Access Compliance Report

Public Rights-of-Way

Intersection ID: 17739	Main Street: E_WOODLAWN_RD	Cross Street: SOUTH_BV	Location: NW
ADA ID: DDBB17B71BE1	Ramp Type: Perp	Initial Pass/Fail: Fail	Overall Compliance: No
			Severity Score: 13.75

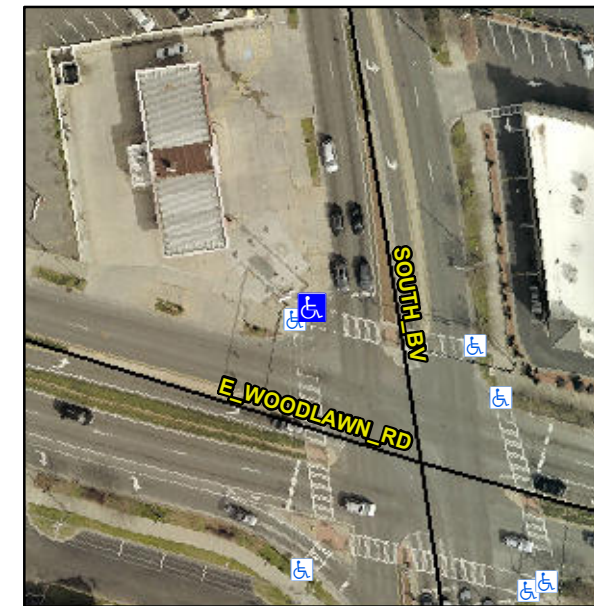
R304.2.2

Compliance	Description	Data	Compliance	Description	Data
N/A	Ramp Length (in)	52.0	No	Ramp Slope (%)	11.6
Yes	Ramp Width (in)	48.0	Yes	Ramp XSlope (%)	2.2
N/A	Flare Type LT	N/A	N/A	Flare Type RT	N/A
N/A	Flare Slope LT (%)	N/A	N/A	Flare Slope RT (%)	N/A
N/A	Flare Traversable LT?	N/A	N/A	Flare Traversable RT?	N/A
N/A	Landing Length (in)	N/A	N/A	DWS Provided?	N/A
N/A	Landing Width (in)	N/A	N/A	DWS Contrast?	N/A
N/A	Landing Slope (%)	N/A	N/A	DWS Length (in)	N/A
N/A	Landing X Slope (%)	N/A	N/A	DWS Full Width?	N/A
N/A	Landing Curb? (Y/N)	N/A	N/A	DWS Offset (in)	N/A
N/A	Shared Landing?	N/A			
N/A	Gutter Ponding?	N/A	N/A	Gutter Slope (%)	N/A
N/A	Gutter Lip Ht (in)	N/A	N/A	Gutter X Slope (%)	N/A
N/A	Painted X Walk1?	Yes	N/A	Painted X Walk2?	N/A
	X Walk 1 Direction	To SE		X Walk 2 Direction	N/A
N/A	X Walk 1 Width (in)	114.0	N/A	X Walk 2 Width (in)	N/A
	X Walk 1 Slope (%)	1.4		X Walk 2 Slope (%)	N/A
	X Walk 1 X Slope (%)	2.9		X Walk 2 X Slope (%)	N/A

Remove & Replace Entire Ramp.
